Indian Point Energy Center
450 Broadway, GSB
P.O. Box 249
Buchanan, N.Y. 10511-0249
Tel (914) 734-6700

NL-10-074

SUBJECT: Response to Request for Additional Information Regarding Generic Letter 2004-02
Indian Point Units 2 and 3
Docket Nos. 50-247 and 50-286
License Nos. DPR-26 and DPR-64

Response to Request for Additional Information Regarding Generic Letter 2004-02

Figure 1: Original IP2 Nukon, Transco Blanket, and fiberglass small pieces debris transport logic tree (IR sump)

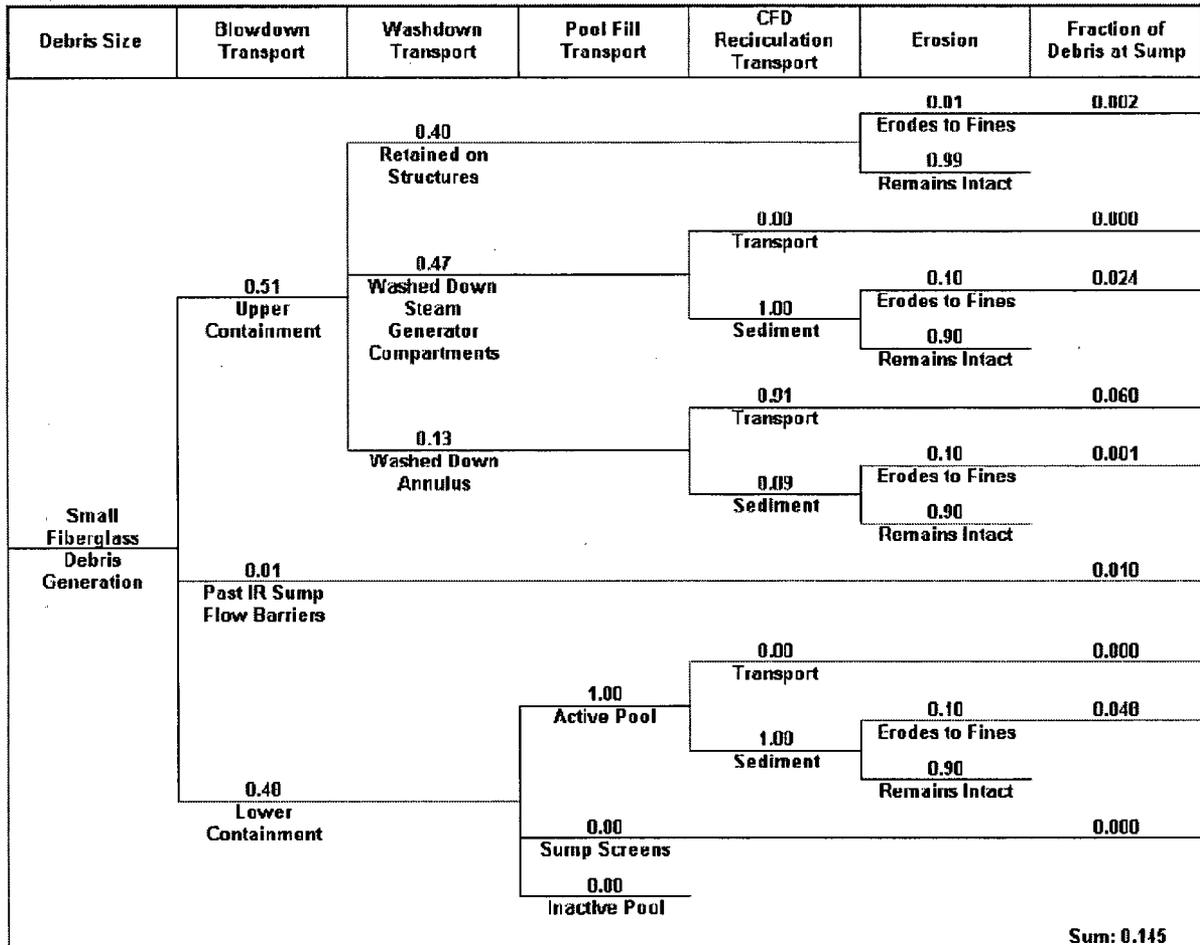
In RAI 1, the NRC staff asked the licensee to provide an adequate technical basis to support the assumption that some percentage of small pieces of fibrous debris will be captured on gratings in the upper containment. The licensee's response stated that the retention percentage assumed 50 percent holdup of small pieces on grating as an input. This assumption in turn was based on drywell debris transport study information (NUREG/CR 6369) which showed for each test case the washdown fraction was less than 50 percent. The response continued with a detailed discussion of associated assumptions, testing, and plant-specific information. The staff considers the licensee response did not adequately address this issue for the following reasons:

- g. *Although the licensee correctly stated that NUREG/CR-6369 indicates that the majority of washdown occurred during the first 15 minutes of testing, it is clear that the NUREG did not conclude that washdown ceases after this time. Without having run tests prototypical of plant conditions (finer debris that is more spread out and potentially lower spray flows), the staff does not agree with the licensee's determination that washdown will effectively cease after 15 or 30 minutes.*

- h. *The Utility Resolution Guidance indicates transport fractions of 1.0 for Mark I and Mark III BWR containments; the corresponding SE modified the Utility Resolution Guidance position to recommend a 1.0 transport fraction for Mark II containments as well. Therefore, no hold up credit for gratings was permitted by the approved analysis methodology used by the BWRs. The staff notes that the licensee's discussion (response Page 80) using the BWR Owners Group washdown data relied on a method the staff did not consider acceptable for BWRs. The staff did not consider the BWR Owners Group washdown testing conservative for its intended use. This also supports the staff's interpretation that NUREG/CR-6369 concluded that no retention should be credited under spray-only conditions.*

This response will evaluate the impact of revising the debris transport methodology to use a higher washdown fraction for small fiberglass debris.

To obtain the "revised" debris transport fractions for small fiberglass pieces due to 100% washdown from upper containment, the debris transport logic trees from the Debris Transport

Calculations were modified. The IP2 debris transport logic tree for Nukon to the IR sump is shown below as an example. The original logic trees for each sump and each debris type required a few changes. The value shown in Figure 1 for "Retained on Structures" under "Washdown Transport" (0.40) was changed to zero, while the "Washed Down Annulus" value was increased to 0.53. Those values were then carried forward through the logic (to the right on the tree) to obtain the revised transport fractions. A summary of the results is shown in Table 1. The revised transport fractions for small fiberglass pieces are approximately twice the original values.

Figure 1: Washdown as a Function of Time Based on NUREG/CR-6369

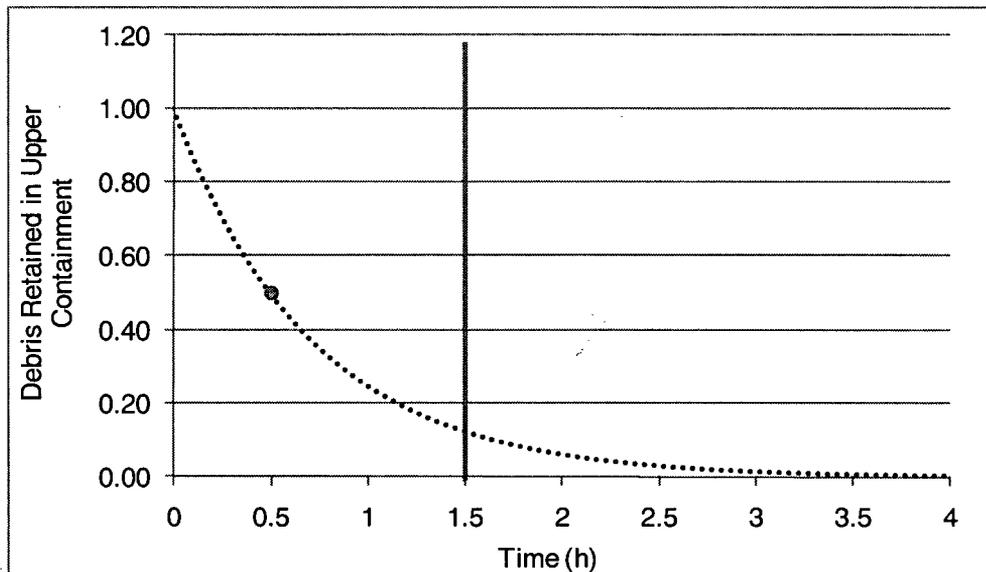
- a. *The licensee assumed debris all washed down prior to switchover, minimizing transport to the VC sump. The RAI response stated if washdown were delayed to 4 hours, the transport of fines to the VC sump would be about 4 percent. The NRC staff finds this response inadequate in that, when a realistic delay is assumed, in conjunction with the other items noted below, it could lead to greater than 5 percent transport to the VC sump.*

The previous RAI response presented an example where washdown was delayed for four hours. This was a hypothetical scenario postulated to demonstrate that the transport to the VC sump would be below 5%; however, the data in NUREG/CR-6369 indicates that a 4 hour delay

is excessive. A more accurate estimation of the total transport fraction can be developed by using a more realistic delay of washdown based on a conservative interpretation of the washdown time data in NUREG/CR-6369. The tests were run for 30 minutes and yielded washdown fractions of less than 50% for 1.5 inch fiberglass pieces. It was also noted in the observations that the majority of washdown occurred in the first 15 minutes. Therefore, a time-dependent washdown curve can be estimated using a data point of 50% washdown at 30 minutes, which predicts a conservatively late washdown. As shown in Figure 1, the majority of washdown occurs in the first 1.5 hours, which is a realistic delay for washdown. Instead of using the previous assumption that all debris is in the pool at the beginning of recirculation (~40 min), it is assumed that all debris enters the pool at 1.5 hours after an accident, or approximately 50 minutes after the start of recirculation (based on IP3 parameters). This reduces the amount of debris collected by the IR sump because of the reduced number of pool turnovers in the first 24 hours. The effect of any small amount of debris that enters the pool after 1.5 hours is offset by assuming that no debris collects on the IR sump prior to 1.5 hours. Additionally, no washdown would occur after 4-6.5 hours into the LOCA scenario because sprays are highly likely to be terminated during this time period in accordance with the Emergency Operating Procedures.

Assuming that the debris in the pool is uniformly distributed and the water entering the pool is clean, an exponential decay model (see Equation 1) based on pool turnovers can be used to estimate the quantity of debris in the pool at 24 hours. This methodology was used in the Debris Transport Calculations to determine the time-dependent debris transport fractions. Using an initial fraction of one and the same conservatively low flow rates (for IP3) and maximum sump pool volumes as the Debris Transport Calculations, Equations 2 – 4 show that debris depletion from 1.5 hours to 24 hours will leave 0.9% of the total debris in the sump pool. This transport fraction will be used in calculating the total debris transport. Note that three equations are needed due to different flow rates for the various time periods after an accident. This assumption and methodology is conservative because it includes all debris (i.e. smalls and fines), not just the debris that is washed down from upper containment.

Figure 2: Turbidity Data for Test C

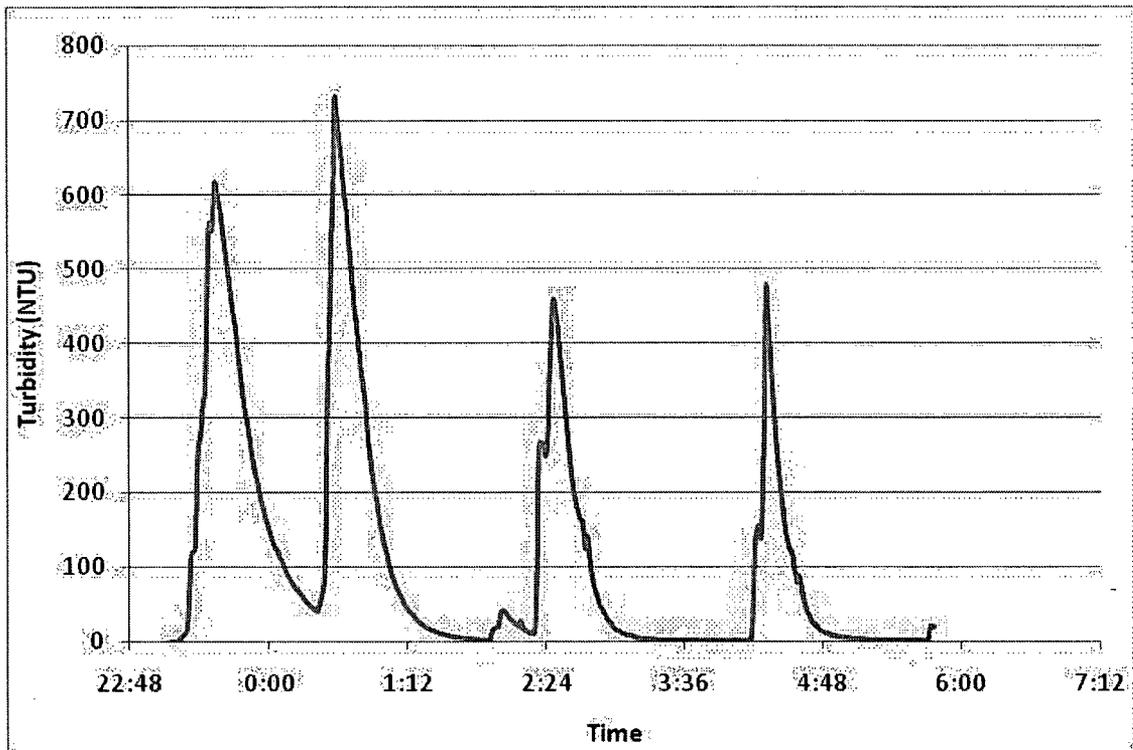
- c. *The licensee indicated that the strainers have bypass eliminator mesh installed, which would significantly reduce the quantity of fibers and some other types of debris that may pass through the strainers. The staff questions, however, whether the 100 percent capture assumption for fine particulate (e.g., 10-micron diameter) is realistic, as simulations have shown that 10-15 pool turnovers are needed to filter out fine particulate for a debris bed of representative porosity. The staff does not agree with the licensee that after 24 hours for a single-train case less than 5 percent of the fine particulate debris would remain in suspension based on the times associated with forming a debris bed with high filtration efficiency and subsequently to achieve 10-15 pool turnovers.*

The capture of particulate debris is dependent on full coverage of the strainers by fibrous debris. If the strainers are fully covered, the fiber acts as an effective filter, and if the strainers have clean screen area, the particulate simply recirculates or settles. Both scenarios will be discussed in detail below.

The prototypical array testing in 2009 also demonstrates that the full debris load on the IR sump is a very effective filter for particulate debris as evidenced by sharp decreases in turbidity after each debris addition. To evaluate this information, the number of pool turnovers required to filter the majority of particulate is determined. Pool turnovers is the appropriate metric to compare the test with the plant because it accounts for the differences in scale. Since very little particulate is required to increase turbidity, it is assumed that turbidity values less than 100 NTUs indicate that very little (<5%) particulate remains in the recirculating fluid. This is reasonable considering that the 25% of particulate added in the first debris addition for Test C increased the turbidity to over 600 NTUs (see Figure 2). For the 4 debris additions in Test C, the time to reduce the turbidity to 100 NTUs ranged from 36 minutes to 14 minutes (see Figure 2). This corresponds to an average of 3.7 pool turnovers, while the minimum number of pool turnovers in the first 24 hours for the Plant is 5.3 and 5.0 for IP2 and IP3, respectively. These pool turnover values are based on the minimum flow rates used in Equations 2 – 4 in the delayed washdown section, and the actual pool turnovers in the Plant could be two or more

times greater. Therefore, a fully covered strainer in the Plant is expected to be an effective filter for particulate in the first 24 hours.
